MARINE ENVIRONMENTAL PROTECTION
COMMITTEE
74th session
Agenda item 5

MEPC 74/5/28
22 March 2019
Original: ENGLISH

EEDI review beyond phase 2 – considerations for Large Tankers

Submitted by INTERTANKO

Figure 1: EEDI baseline for VLCCs lower than the average of data used for regression

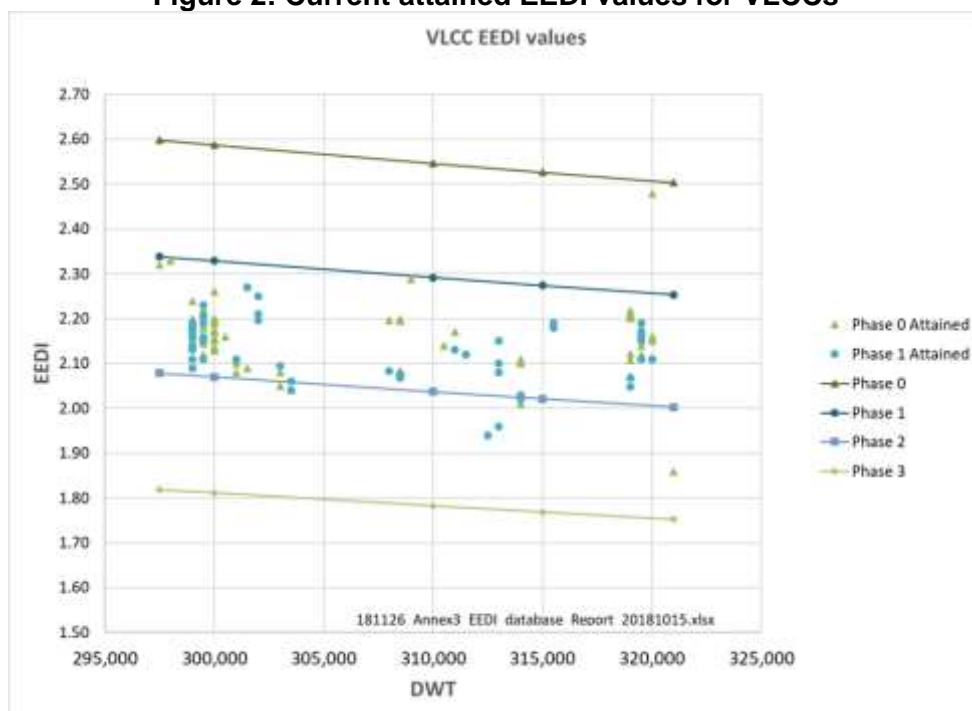
8 The inset is a close up of the data in the VLCC range. The solid blue line is the current baseline. The grey line is simply an average of the VLCCs and ULCCs originally considered. From the above, we would make the following observations/conclusions:

- .1 the baseline was originally drawn below the average of the existing ships in the VLCC size range. This is as indicated in document MEPC 60/4/33 showing that the large tankers started out with a more difficult challenge than small tankers and other ships types where the baseline was at or above the mean line;
- .2 the new ships are clearly better than the baseline ships but not yet to Phase 2 levels. On average the new ships (yellow dots) are about 18% lower than the original fleet (blue dots) and represent a good estimate of the EEDI improvements that are actually possible with hull optimization, speed reductions and some application of "advanced technologies"; and
- .3 if the simple average grey solid line is used as the baseline (at EEDI = 2.631), the required EEDI for Phase 2 would = 2.105. Consequently, about 15 of the "new" ships comply with this new Phase 2.
